Re: Castle Valley Mining LLC
Castle Valley Mines
NOV- 10068 Abatement
Permit No. C/015/0025

Detailed Schedule Of Changes to the Mining And Reclamation Plan

Permittee: Castle Valley Mining LLC
Mine: Castle Valley Mines
Title: NOV-10068 Abatement
Permit Number:
C/015/0025

Ditch D-8D (Concrete Lined)Material: Concrete*Trapezoidal Channel*

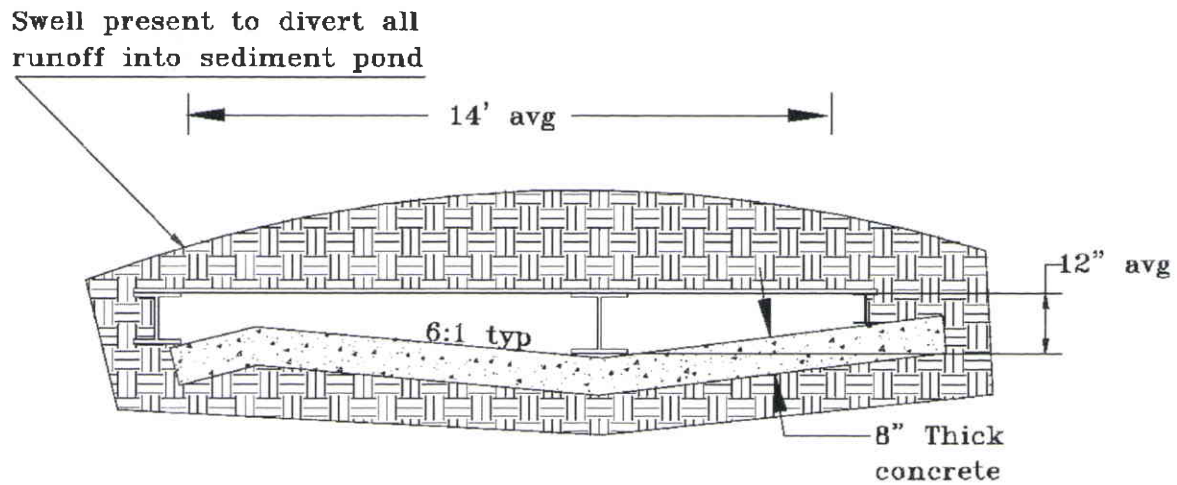
<input type="checkbox"/> Add	<input checked="" type="checkbox"/> Replace	<input type="checkbox"/> Remove	Page 7G-108, Added design information for Ditch D-8D, Remove text regarding Water Bar
<input type="checkbox"/> Add	<input checked="" type="checkbox"/> Replace	<input type="checkbox"/> Remove	Page 7G-129, Remove Water Bar design, replace SedCad design for Ditch D-8D (Concrete)
<input checked="" type="checkbox"/> Add	<input type="checkbox"/> Replace	<input type="checkbox"/> Remove	Page 7G-107A, Add design for new Culvert C-14D
<input type="checkbox"/> Add	<input checked="" type="checkbox"/> Replace	<input type="checkbox"/> Remove	Page 5A-2, Added new Valve Box to Table 5A-1, Existing Structures
<input type="checkbox"/> Add	<input checked="" type="checkbox"/> Replace	<input type="checkbox"/> Remove	Page 5A-10, Added Structure #29, Culinary Water System Valve Box with short description
<input type="checkbox"/> Add	<input checked="" type="checkbox"/> Replace	<input type="checkbox"/> Remove	Plate 5-2B, Added Concrete Lining on Ditch D-8D, Removed Water Bar, changed haul rd. color

Bottom Width (ft)	Left Sideslope Ratio	Right Sideslope Ratio	Slope (%)	Manning's n	Freeboard Depth (ft)	Freeboard % of Depth	Freeboard Mult. x (VxD)
1.50	1.0:1	1.0:1	2.0	0.0150	0.30

w/o Freeboard	w/ Freeboard
Design Discharge:	1.23 cfs	
Depth:	0.18 ft	0.48 ft
Top Width:	1.86 ft	2.46 ft
Velocity:	3.99 fps	
X-Section Area:	0.30 sq ft	
Hydraulic Radius:	0.151 ft	
Froude Number:	1.74
